May 2022
SF653A-D

Subject: Western Star 49X SRR Overwrite Sensor Mounting Data Update

Models Affected: Specific model years 2021-2022 Western Star 49X model vehicles manufactured February 10, 2020, through August 12, 2021.

Daimler Truck North America LLC (DTNA), on behalf of its wholly owned subsidiary, Western Star Truck Sales, Inc., is initiating Field Service Campaign SF653 to modify the vehicles mentioned above.

Fig. 3, Setting Parameter Overwrite Sensor Mounting Data

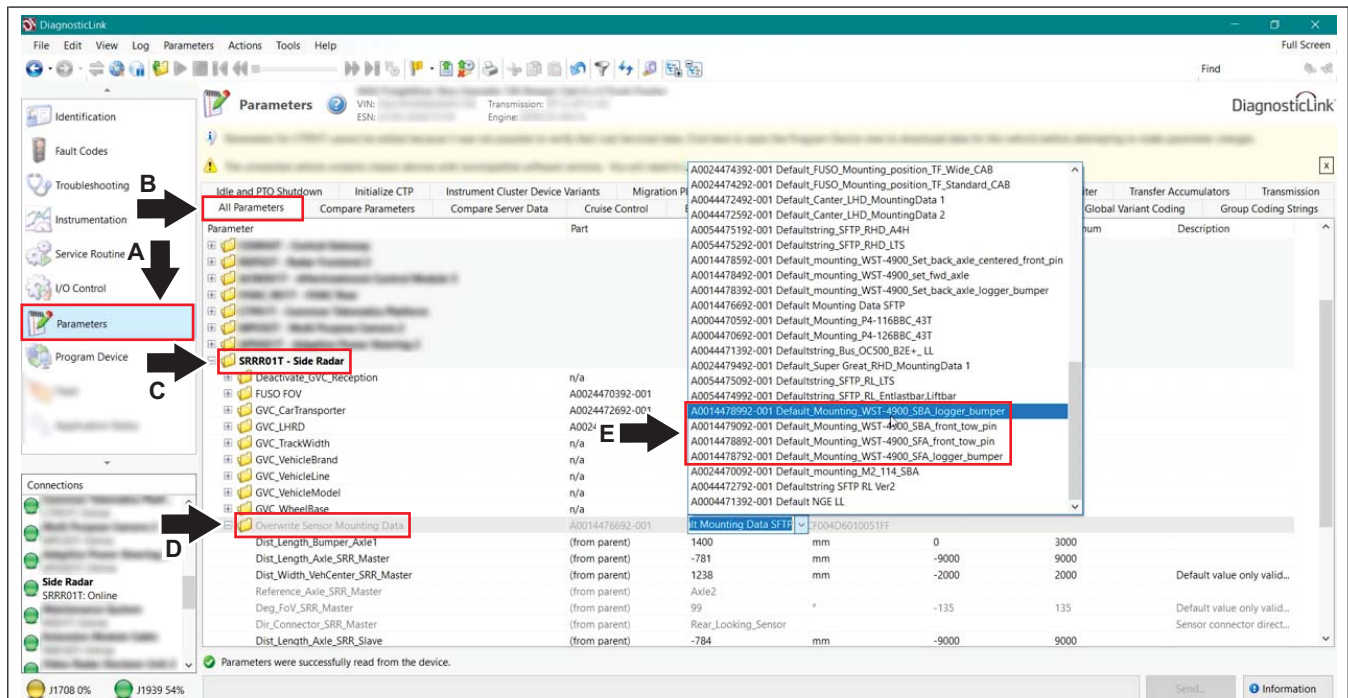
- After the server data download is complete, go to the 'Parameters' tab. In the 'All Parameters' tab, go to 'SRRR01T – Side Radar' folder, then select the 'Overwrite Sensor Mounting Data' parameter. Set the parameter value for the applicable campaign population shown in **Table 2**. See **Fig. 3**.

| SRRR01T Overwrite Sensor Mounting Data Parameter Values | |
| Campaign Group | SRRR01T 'Overwrite Sensor Mounting Data' Parameter Setting |
| SF653A | A0014478792-001 Default_Mounting_WST 4900_SFA_Logger_bumper |
| SF653B | A0014478892-001 Default_Mounting_WST 4900_SFA_front_tow_pin |
| SF653C | A0014478992-001 Default_Mounting_WST 4900_SBA_Logger_bumper |
| SF653D | A0014479092-001 Default_Mounting_WST 4900_SBA_front_tow_pin |

- Go to the 'Parameters' tab.
- Select 'All Parameters.'
- Go to 'SRRR01T – Side Radar' folder.
- Select 'Overwrite Sensor Mounting Data' parameter.
- Set the parameter value according to the vehicle population.
